# ALLOWABLE/CONDITIONAL USE PERMIT APPLICATION

*Multifamily Housing Development off Vista Drive. Four 10-unit buildings for 040 units total.*

This letter summarizes modifications or additions we are making to the Hillside Endorsement application package submitted on August 30, 2013. These changes are being made to better address or clarify items in the application package. We are referencing specific sections of the application with direction on supplementing the existing information or replacing it in its entirety.

**JVOA - JUNEAU I HOUSING  
 HILLSIDE ENDORSEMENT  
 PERMIT SET**

SHEET NO.  
 C3.2  
 of  
 16

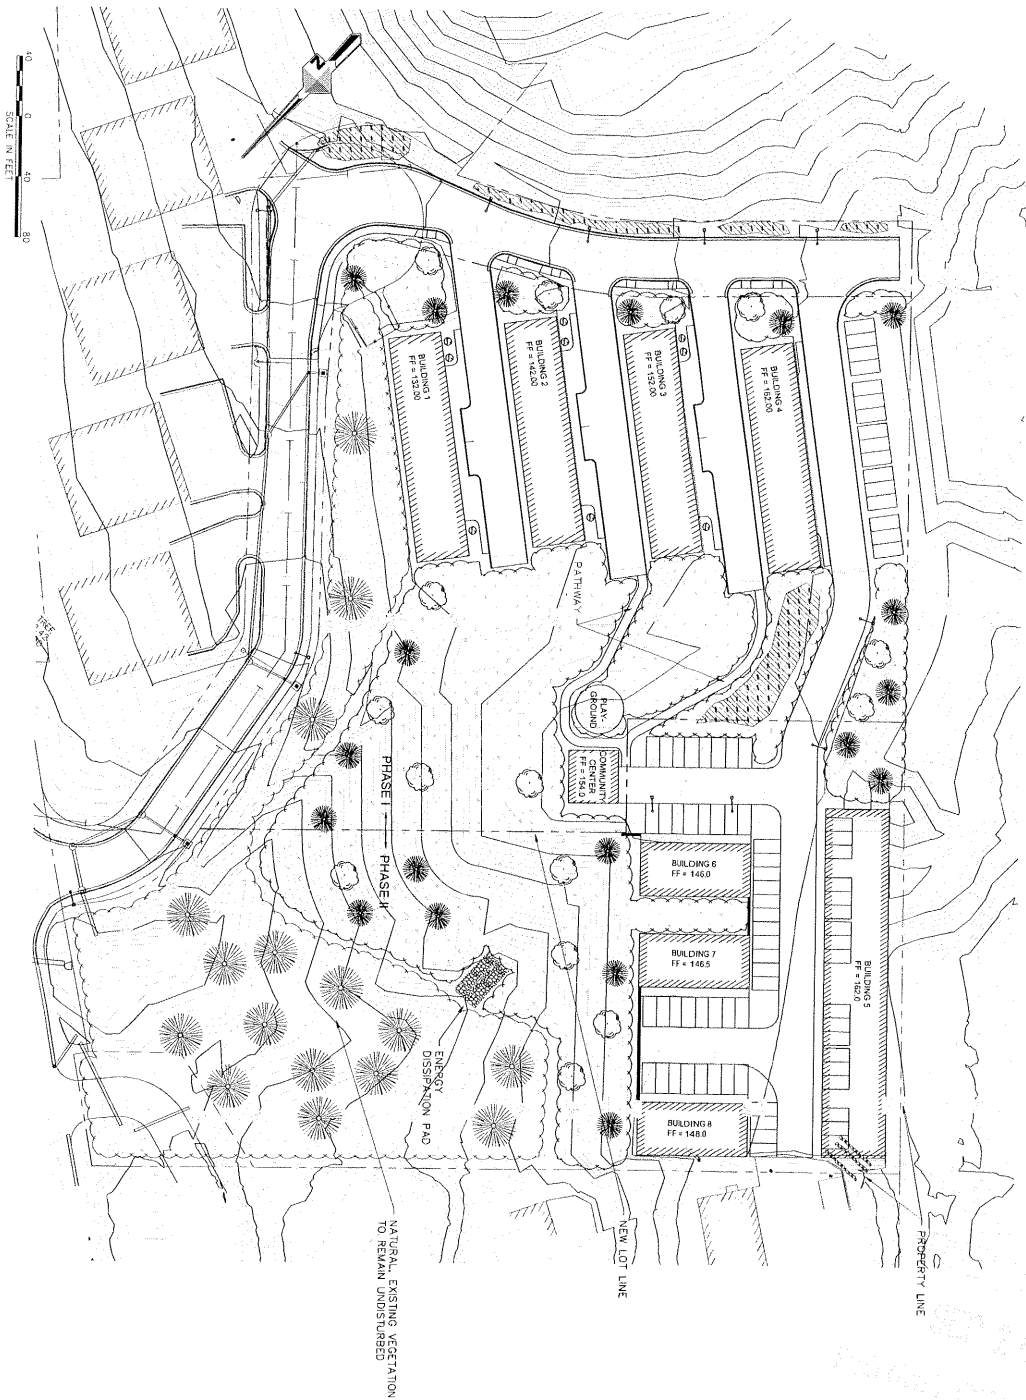
- a. COVER SHEET, G1.0 – Changes as noted.
- b. LANDSCAPING SITE PLAN, C3.2 – Sheet name and purpose is changed to Vegetative Cover. Separate Landscaping sheets are added included below.
- c. SITE GRADING PLANS, C5.1 & C5.2 – Luminaire pole locations corrected and other minor changes.
